HISTORIC AND DESIGN REVIEW COMMISSION

Agenda Item No: 19

HDRC CASE NO: 2016-239
ADDRESS: 3903 N ST MARYS
LEGAL DESCRIPTION:
ZONING: R6 HS RIO-1
CITY COUNCIL DIST.: 2
LANDMARK: Brackenridge Park
APPLICANT: Cosmo Guido/Guido Brothers Construction
OWNER: San Antonio Zoo
TYPE OF WORK: Renovations to Lion's Den Habitat
REQUEST:

① ELEVATION - SOUTH
1/4" = 1'-0" Ref: 1 / A200

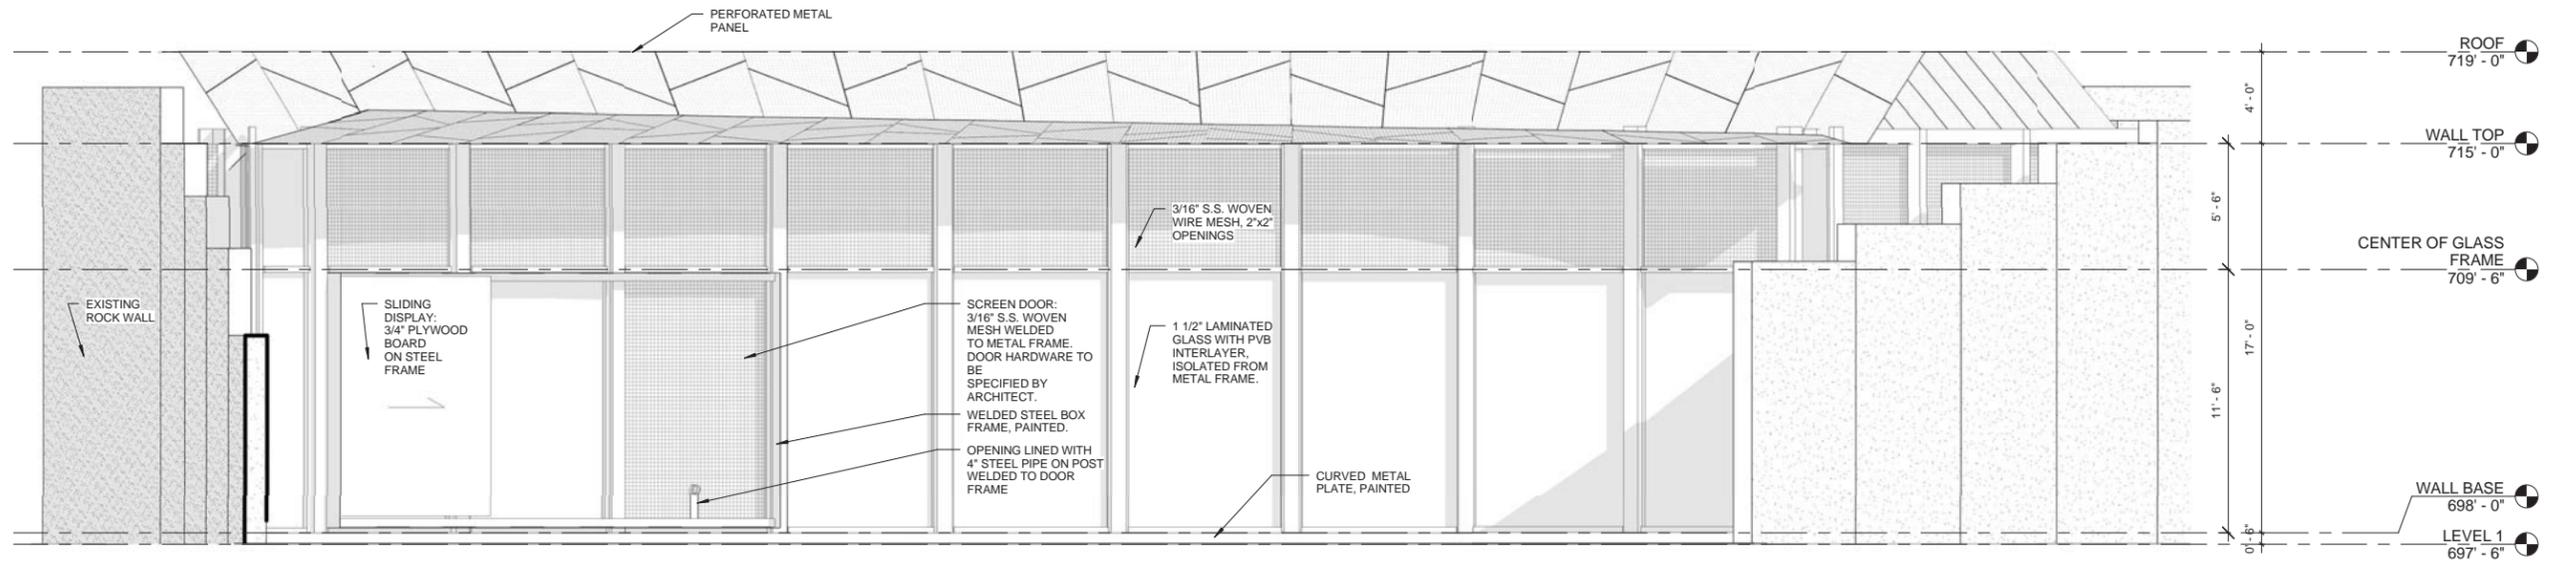
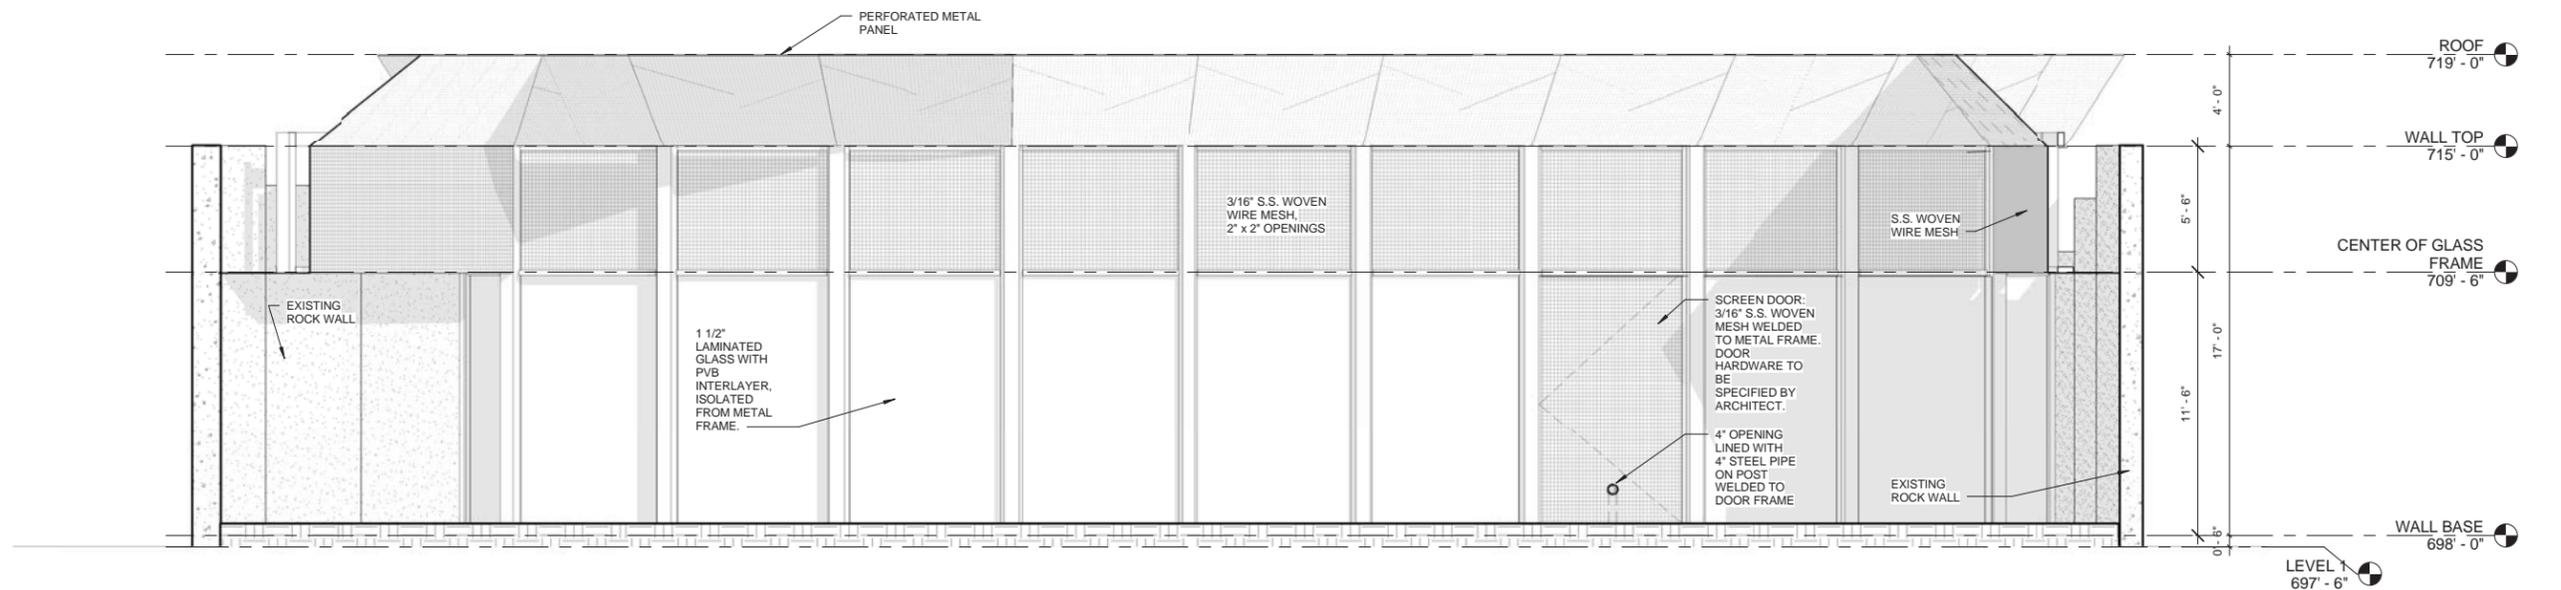
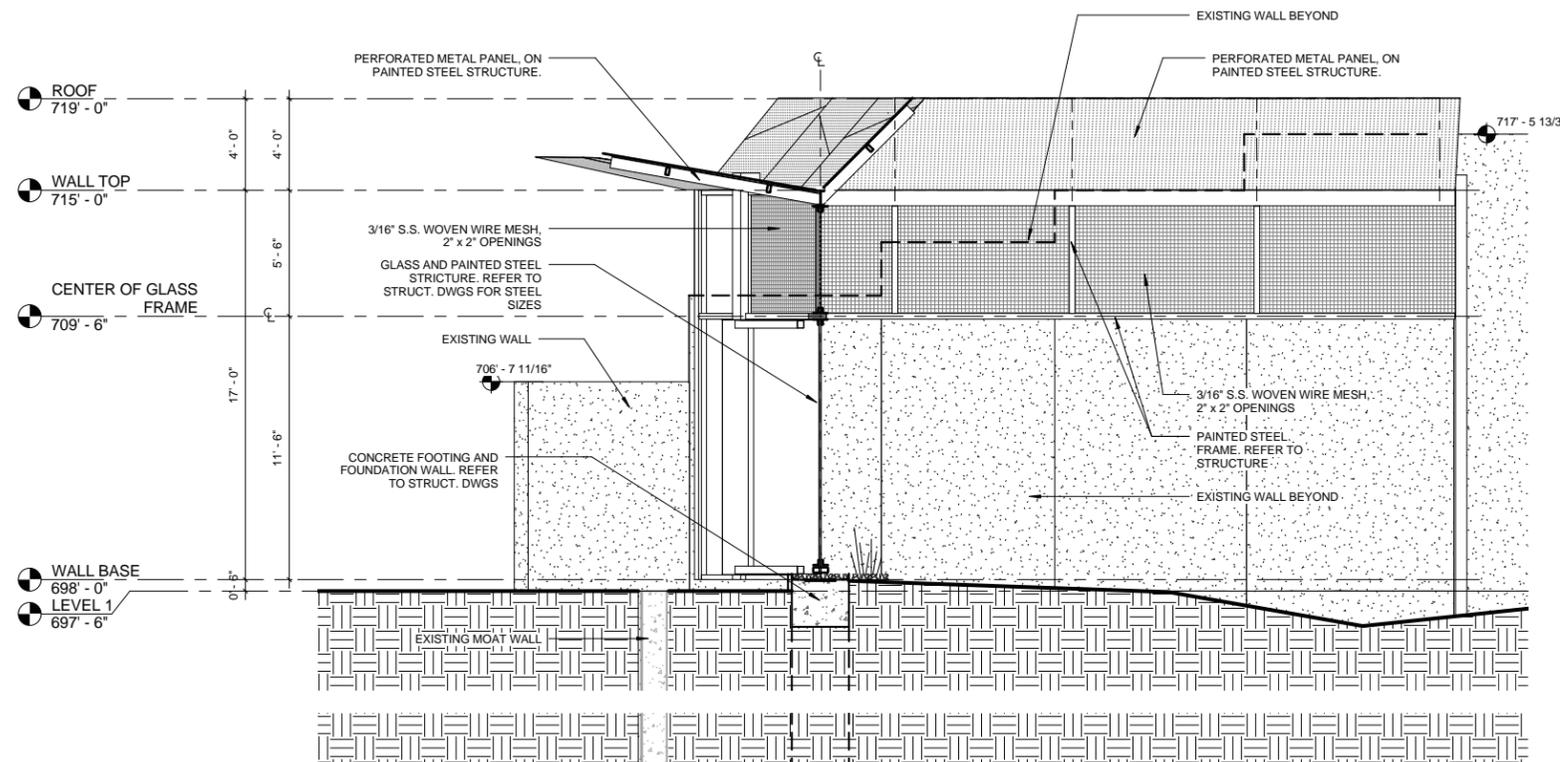
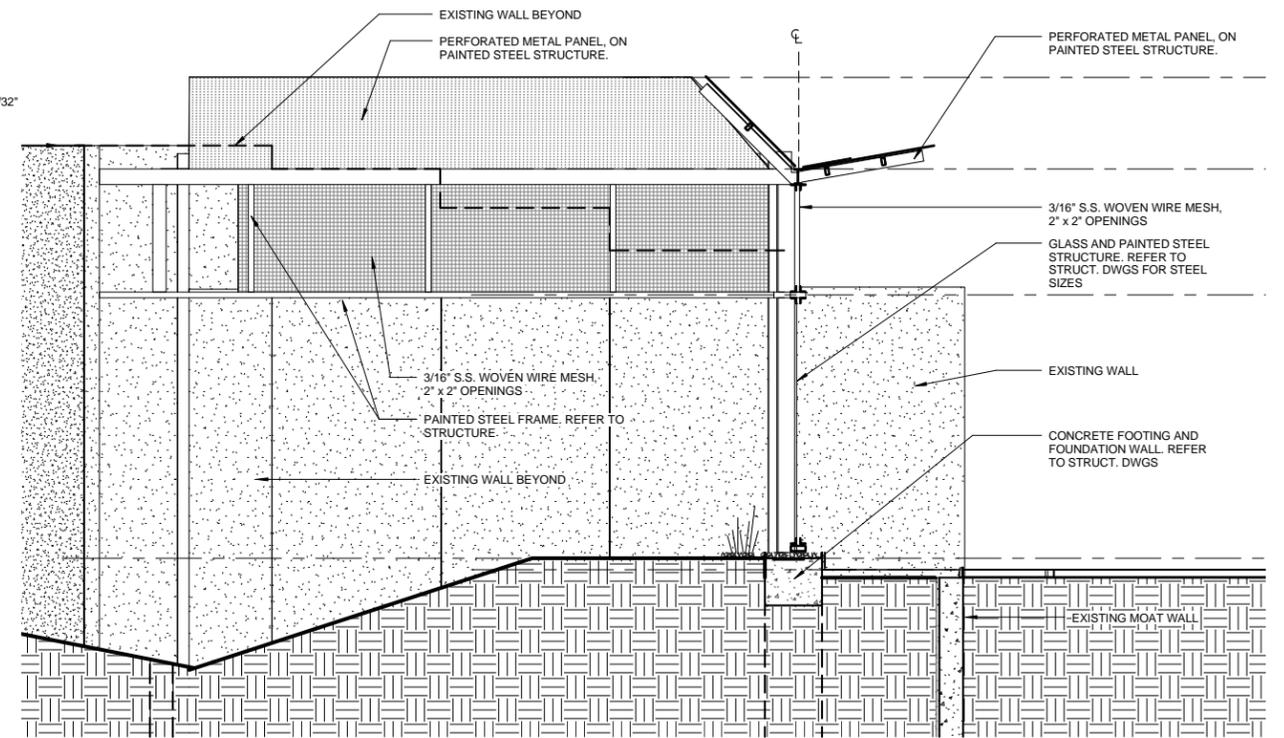
- b. The applicant has proposed to construct a new vision wall consisting of a steel frame with laminated glass panels. The steel and glass wall will be approximately seventeen (17) feet in height. A new signage location to the side of the proposed new wall will be installed. The applicant has noted that the existing trees will be preserved. Staff finds this request appropriate.
